Access Compliance Report Public Rights-of-Way (Curb Ramps)

Main Street: N/A Cross Street: TRIAD_LN Location: SE

ADA ID: RPRK211028114436 Ramp Type: Type 4 - Parallel Initial Pass/Fail: Fail Overall Compliance: No Severity Score: 2

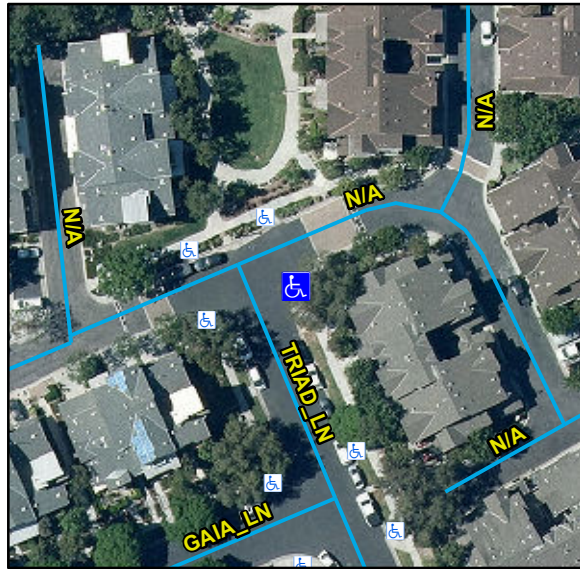
Compliance	Description	Data	Compliance	Description	Data
N/A	Ramp Length LT (in)	134	N/A	Ramp Length RT (in)	133
Yes	Ramp Width LT (in)	53	Yes	Ramp Width RT (in)	53
Yes	Ramp Run Slope LT (%)	5.6	Yes	Ramp Run Slope RT (%)	0.8
No	Ramp Cross Slope LT (%)	2.7	Yes	Ramp Cross Slope RT (%)	1.9
N/A	Landing Present	N/A	N/A	DWS Provided	N/A
N/A	Landing Length (in)	N/A	N/A	DWS Contrast	N/A
N/A	Landing Width (in)	N/A	N/A	DWS Length (in)	N/A
N/A	Landing Run Slope (%)	N/A	N/A	DWS Full Width	N/A
N/A	Landing Cross Slope (%)	N/A		DWS Offset Type	N/A
N/A	Landing Movement Obstructed?	N/A	N/A	DWS Offset Left (in)	N/A
	Landing Movement Type	N/A	N/A	DWS Offset Right (in)	N/A
N/A	Landing Shared	N/A			
N/A	Clear Space	Yes			
N/A	Clear Space To Crosswalk (in)	N/A			
N/A	Marked Crosswalk 1	No	N/A	Marked Crosswalk 2	No
	Crossing 1 Direction	N		Crossing 2 Direction	W
	Marked Crosswalk 1 Width (in)	N/A		Marked Crosswalk 2 Width (in)	N/A

Remove & Replace Curb Ramp With Two New Directional Ramps or Equivalent.

R204.3, R304.5.3, STD 1115
